A. Pre 1984 Merc 18 & 25 Lower Units Below The Following Serial Numbers:

B. 1984 Merc 18XD & 25XD Electric (E& EL) Models

CIRCULATE TO:
SERVICE MANAGER
PARTS MANAGER
MECHANICS
"Place in a Service
Bulletin Binder"

Gear Housing With .234" (5.94mm) Thick Thrust Washer (96524) Above Pinion Gear

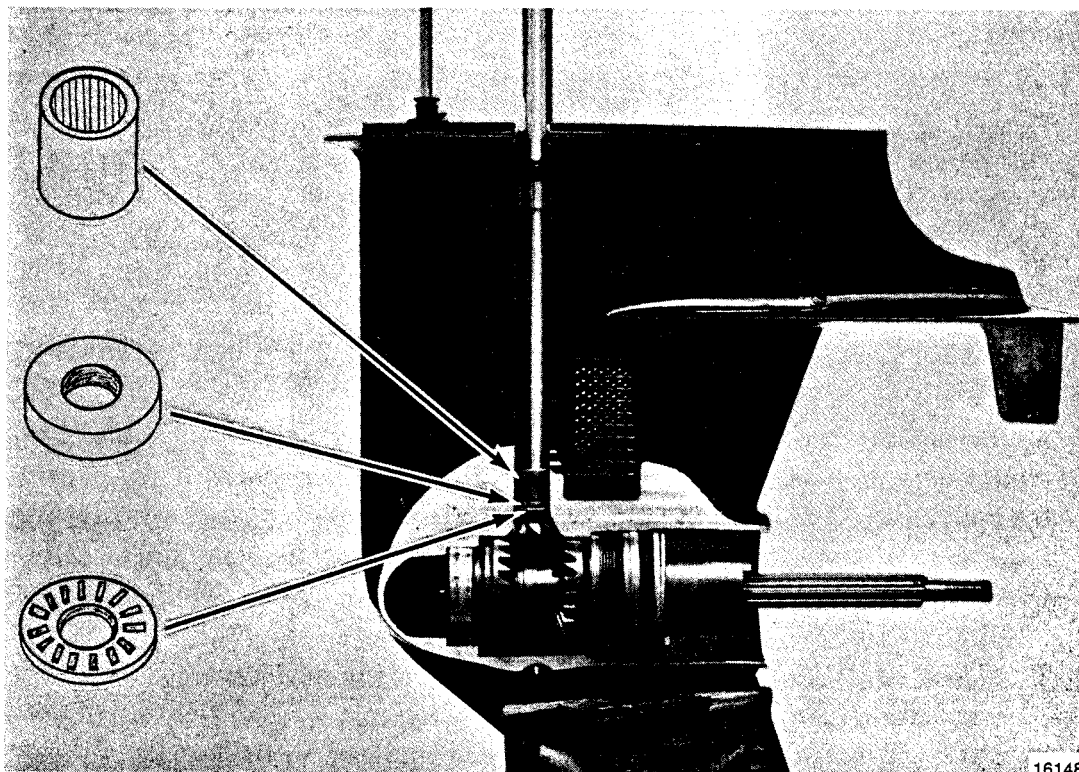
DO NOT install this bushing in a gear housing that is equipped with .080" (2.03mm) thick thrust washer (12-94056) above pinion gear or gear housing damage may result.

IMPORTANT: This bushing replaces .234" (5.94mm) thick Thrust Washer (96524), lower Driveshaft Bearing (31-85559), and Thrust Bearing (31-85560) in Merc 18 and 25 HP gear housing assemblies equipped with .234" (5.94mm) thick thrust washer.

1. Refer to Step 1 for component removal.
2. Refer to Step 2 for bushing installation.

Remove and discard thrust bearing, thrust washer, and lower driveshaft bearing.

STEP 2 Install Bushing as Shown

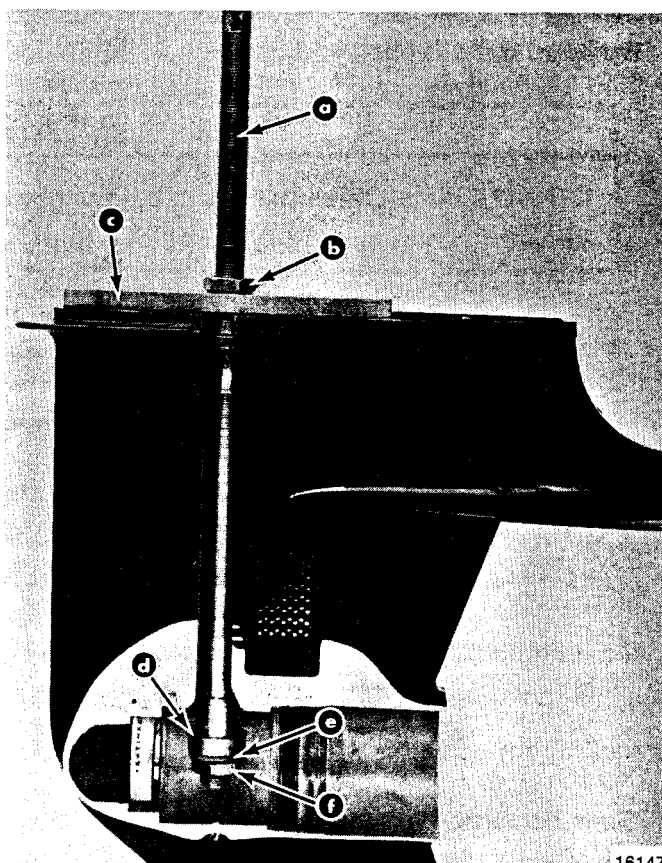
1. If a replacement bushing is required, order 98861A1 to receive the bushing and installation instructions.
2. When .234" thick thrust washer is ordered, it will be superseded by bushing 98861A1 and installation instructions.
3. DO NOT install bushing in a gear housing equipped with .080" thick thrust washer or gear damage will occur.

- Hold threaded rod so that it will not rotate, then tighten upper nut against metal plate, to pull bushing into drive shaft bore.
- Tighten nut until large shoulder of bushing is firmly seated against gear housing.

- a - 5/8" O.D. Threaded Rod (or Puller Shaft 91-31229)
- b - Nut (Upper)
- c - Metal Plate (or Puller Plate 91-29310)
- d - Bushing (Small O.D. Beveled Edge Toward Top of Gear Housing)
- e - Washer (1-3/16" O.D. x 5/8" I.D.) or Mandrel
- f - Nut (Lower)

Figure 1.

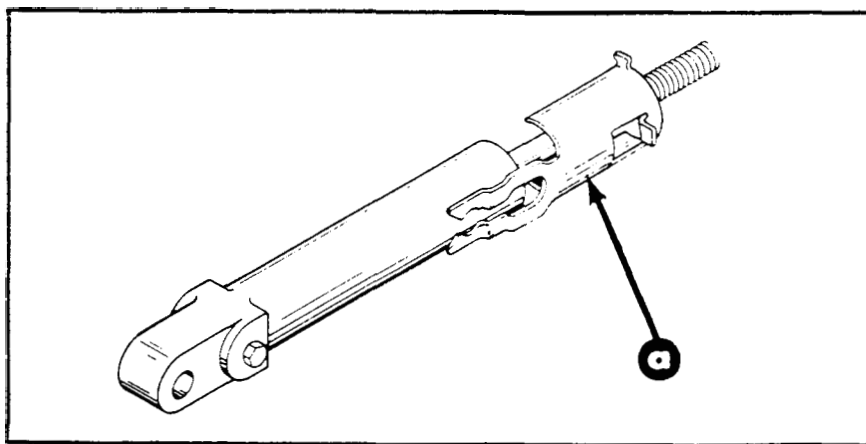
Some competitive remote control cables cannot be used on the 1984 electric models.

The reason is that quick connect cable retainers were specifically designed to fit the round cable guides used on Quicksilver remote control cables. (Figure 1)

Some competitive remote control cables have cable guides with different contours and the quick connect cable retainers cannot be easily adapted. This is another reason to use only genuine Quicksilver parts and accessories.
